SIB 64 04 25

SERVICE ACTION: MODIFY HARNESS ROUTING AT THE NEXT NANOFILTER REPLACEMENT

This Service Information Bulletin (Revision 3) replaces SI B64 04 25 **dated July 2025**.

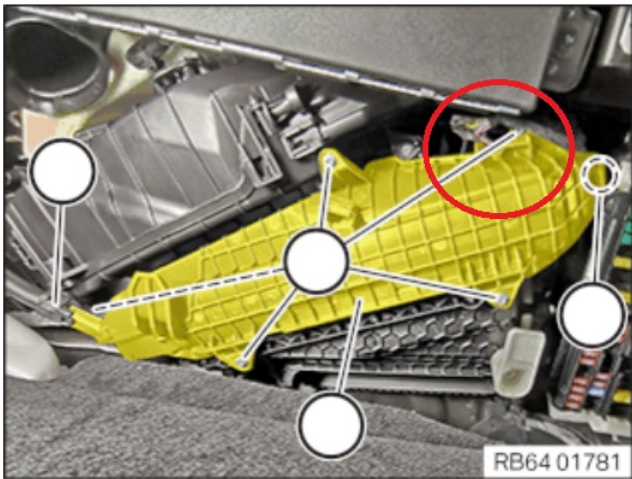
Add a retainer to the harness to prevent it being pinched under the air filter plastic cover.

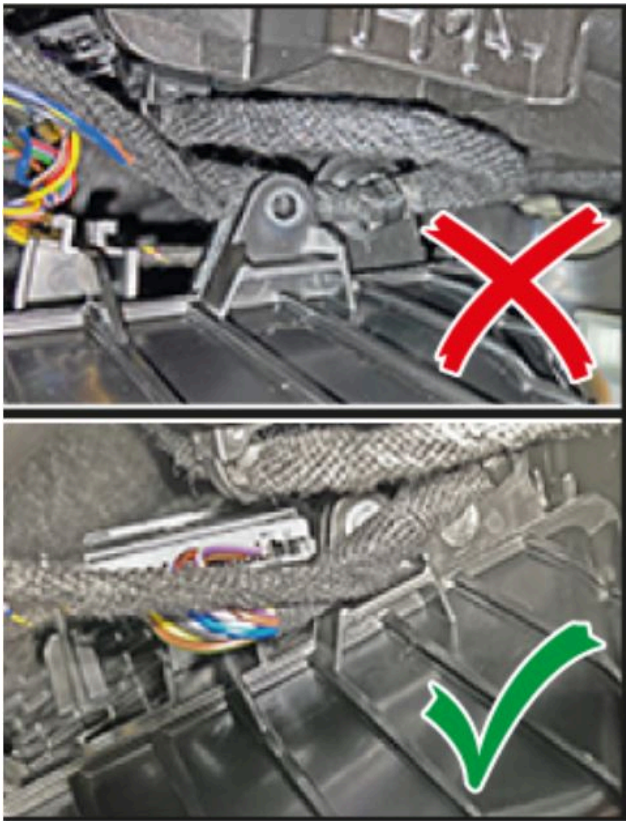
When following Repair Instructions REP 64 31 010 to change the cabin air nanofilter, check the vehicle wiring harness routing (circled) before fastening the plastic cover over the filter.

This is where the harness can be damaged when installing the cabin air filter cover screw.

This shows the harness damage; the sheathing has been abraded.

With the harness pulled out of the way, you can see the screw mounting hole for the cabin air filter cover.

Double check the routing of the harness prior to installing the screws for the cabin air filter cover.

If the wiring harness has already been damaged during the installation of the cabin air filter cover, the damaged section of the wiring harness must be repaired.

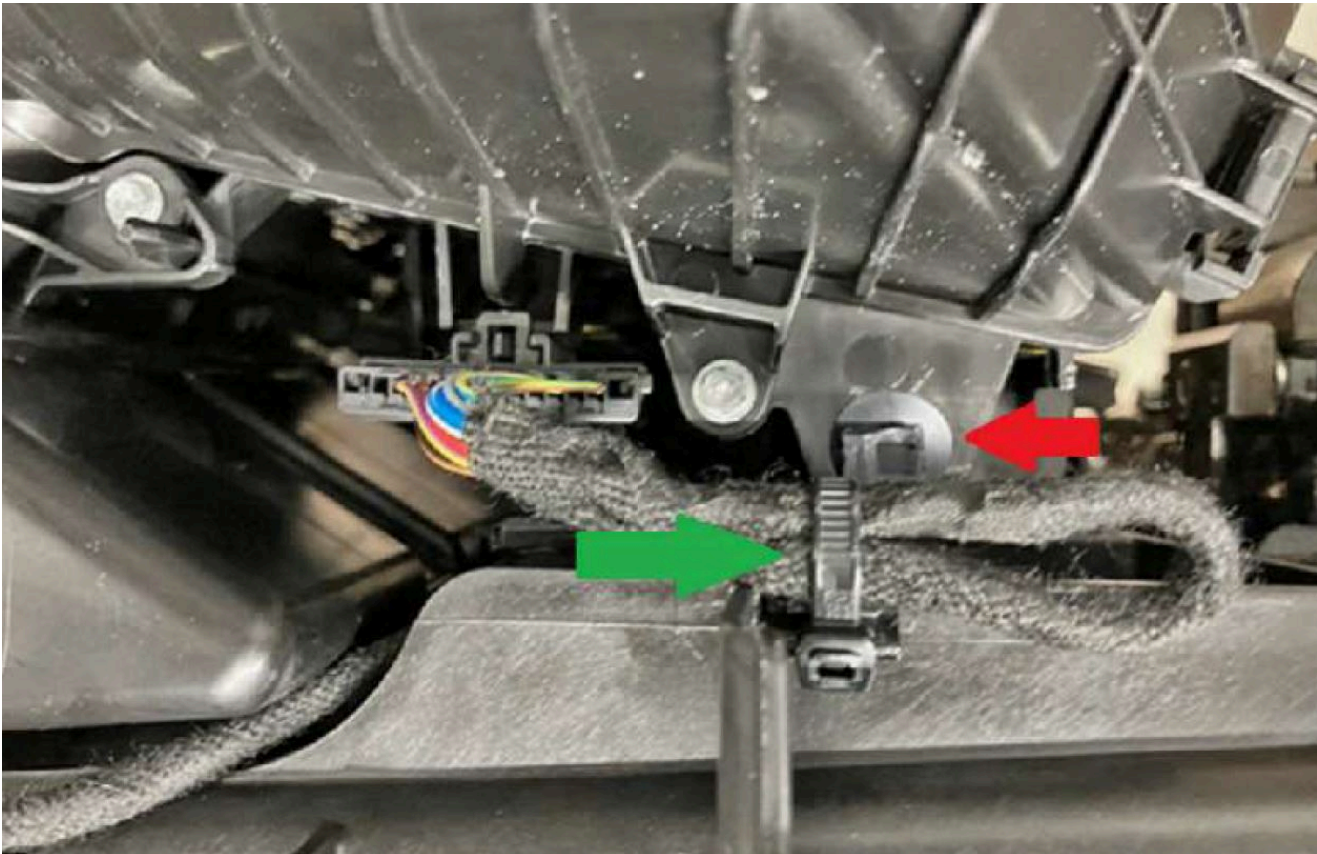
The original harness retainer must be disconnected. This is shown by the red arrow below. It can be left clipped into vehicle but must be disconnected from harness for strain relief.

Install a new harness retainer with cable strap on the Instrument Panel wiring harness, see green arrow.
